Drayton South Coal Project Air Quality Review

This report has been prepared for the Department of Planning and Environment (DPE) to assist with their assessment of the Drayton South Coal Project (the 'Project'). The report provides outcomes of a peer review of documents relating to potential air quality impacts of the Project, specifically:

**Drayton South Coal Project
Response to Air Quality Peer Review**

Drayton South Coal Project Response to Air Quality Review

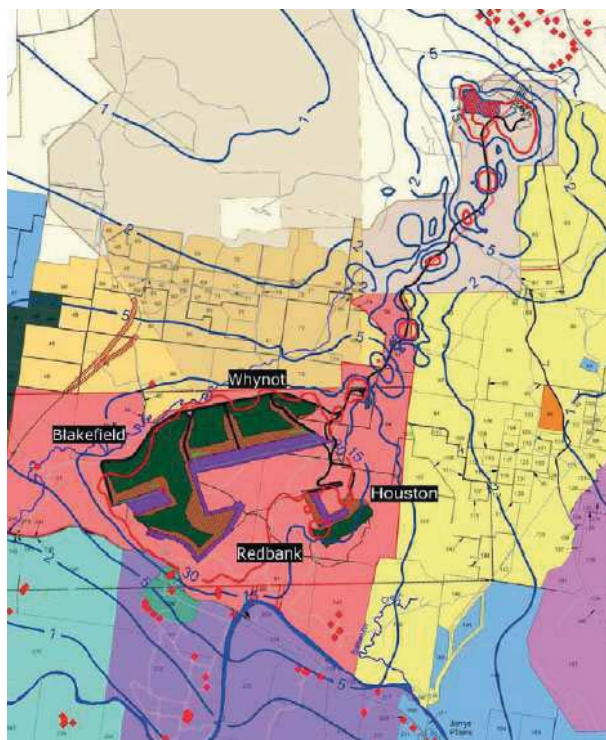
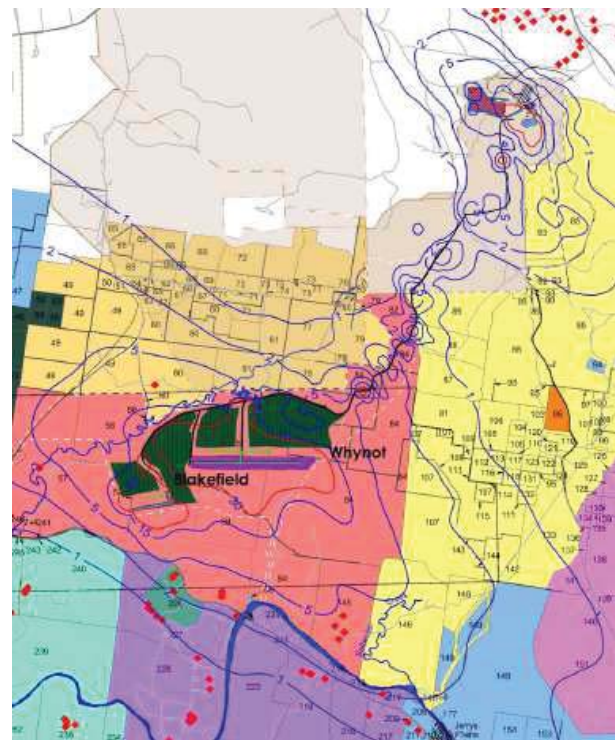
The figures below show the predicted annual average PM₁₀ concentrations due to the Project, in its original and current form, as an indication of the change in potential impacts. These predictions are as expected, given the history of emission estimates and modifications to the project since the original Environment Assessment was completed.

Reviews of emission calculations, methods for assessment and models have been undertaken. With regards to the original and current proposals it is concluded that:

- The changes in predicted impacts are reasonable, reliable and suitably modelled; and
- The modelling provides a reasonable basis for the Department's assessment of the likely impacts associated with the revised project (SSD 6875).
